Application for Licence Amendment

Licence Number	L8675/2012/1
Licence Holder	Millennium Minerals Limited
ACN	003 257 556
File Number	DER2014/002927-1~6
Premises	<p>Nullagine Gold Operation - Golden Eagle Project</p> <p>Mining Tenements M46/3, M46/47, M46/50, M46/57, M46/64, M46/98, M46/129, M46/138, M46/146, M46/163, M46/164, M46/166, M46/167, M46/170, M46/182, M46/186, M46/187, M46/189, M46/192, M46/198, M46/199, M46/200, M46/225, M46/261, M46/262, M46/263, M46/264, M46/265, M46/266, M46/267, M46/272, M46/273, M46/274, M46/275, M46/276, M46/277, M46/278, M46/279, M46/282, M46/283, M46/300, M46/302, M46/303, M46/426, M46/427, M46/428, M46/429, M46/430, M46/431, M46/432, M46/433, M46/434, M46/436, M46/441, M46/442, M46/443, M46/444, M46/445, M46/446, M46/447, M46/448, G46/2, L46/33, L46/45, L46/88, L46/89, L46/90, L46/91, L46/92, L46/98, L46/105, L46/115, P46/1670, P46/1671, P46/1672, P46/1673, P46/1674, P46/1675, P46/1676, P46/1703, P46/1704, P46/1705, P46/1706, P46/1707, P46/1757, P46/1758, P46/1759, P46/1760, P46/1761, P46/1804, P46/1823, P46/1824, P46/1855, and P46/1856</p> <p>NULLAGINE WA 6758</p>

Date of Report	5/11/2021
Decision	Revised licence granted

Figure 1: TFS2 and power station locations.

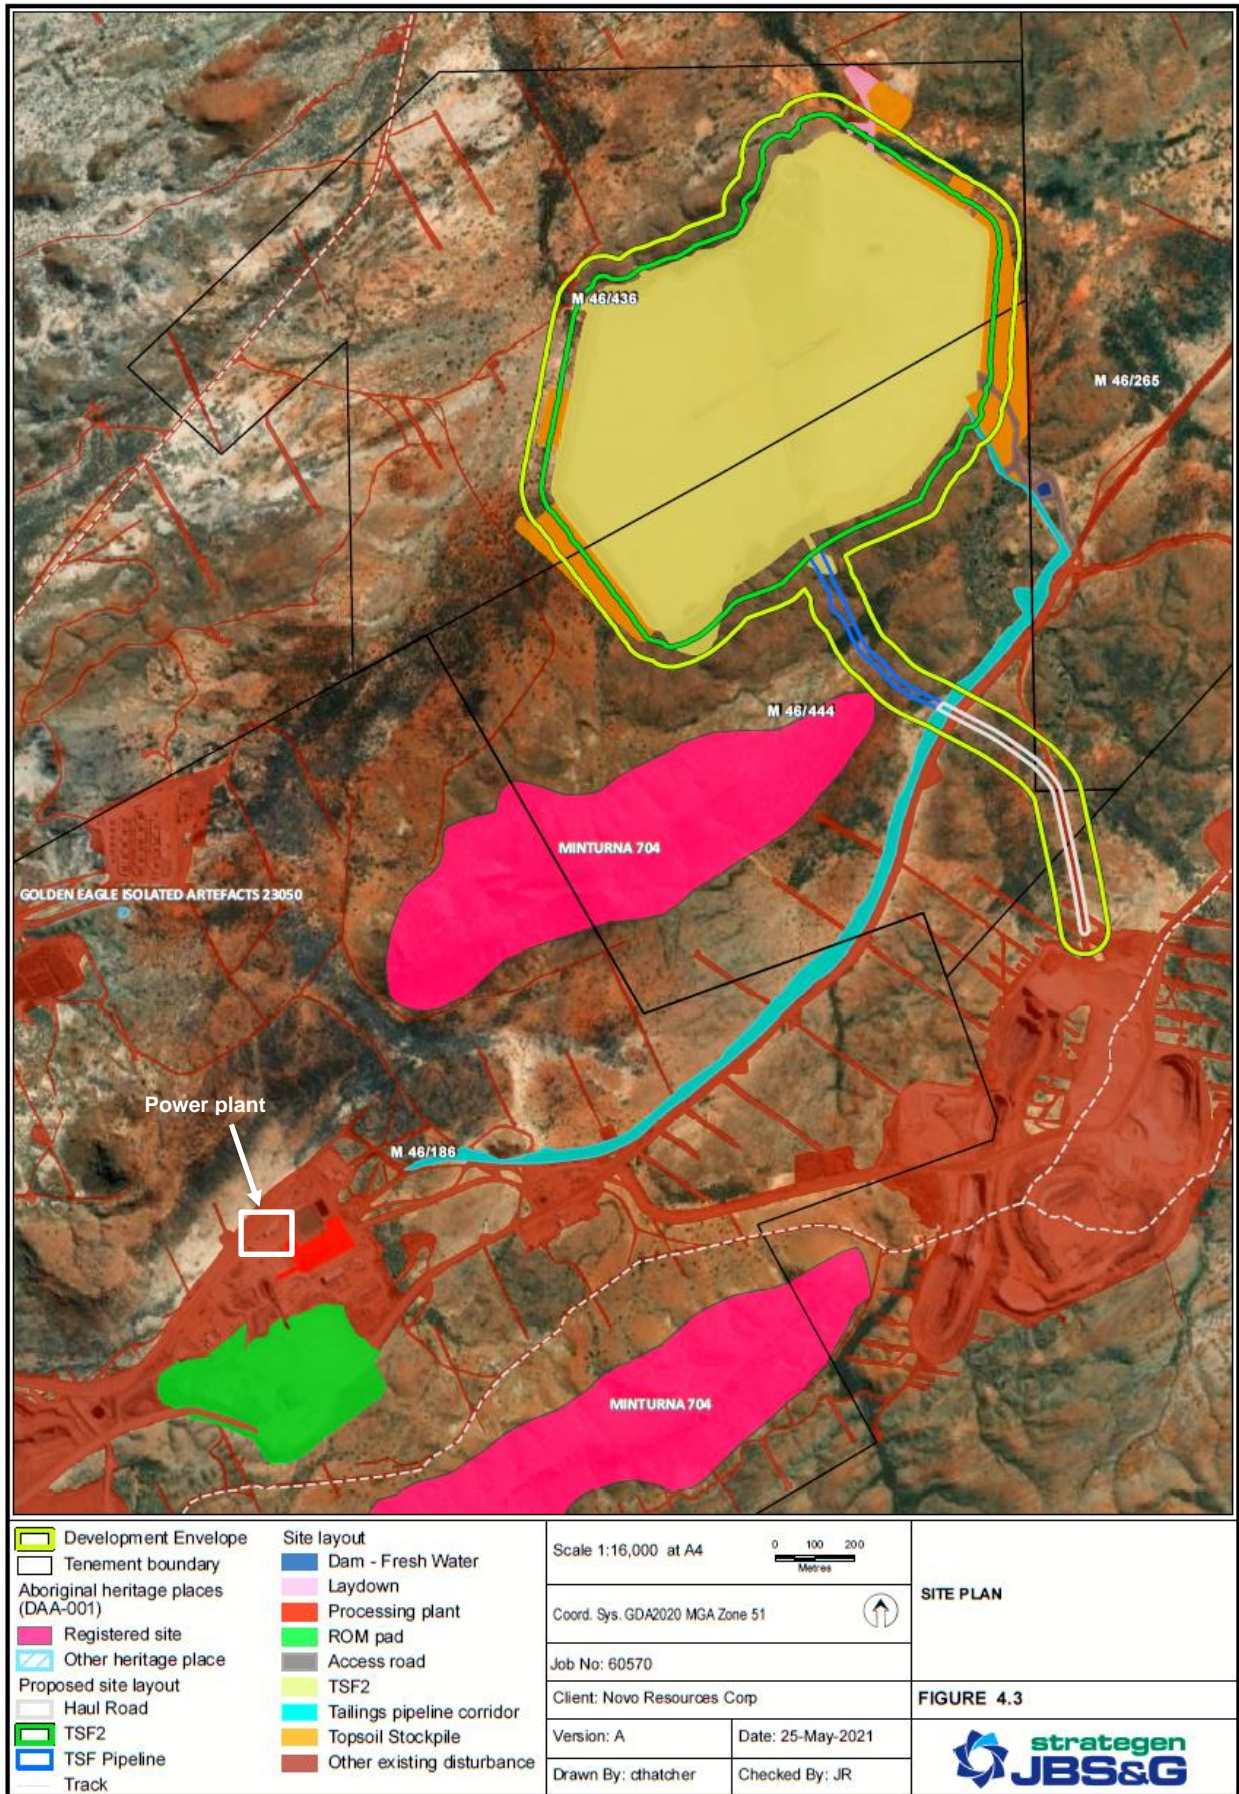
The Licence holder applied for a downstream lift (stage 2) of TSF2. The original application was for a raise in crest height of 4m, in two stages of 4m each. However, during assessment of this amendment application, DWER became aware that the 'interim' lift (stage 2A) has already been constructed. Previous approval for construction of TSF2 to 399m RL under Amendment Notice 1 (issued 14 March 2017) was for construction using an upstream lift method and 2 cell layout. The Licence Holder has deviated from this design and the raises cannot be constructed according to the previously approved design. The construction of the raise cannot be retrospectively approved by DWER. The Licence Holder submitted an application addendum on 28 October 2021 requesting approval to operate (deposit tailings into) the Stage 1A lift only. A report detailing the construction works undertaken for the interim raise to crest

The TSF2 tailings delivery lines and decant return lines are proposed be relocated to within a constructed bunded footprint.

Figure 1 shows the new pipeline route, areas to be cleared and the approximate new TSF2 footprint.

height 397.3m RL (REC 2021) was submitted on 27 October 2021. Approval for construction or operation beyond this height is not provided in this amendment, and will be the subject of a future amendment application.
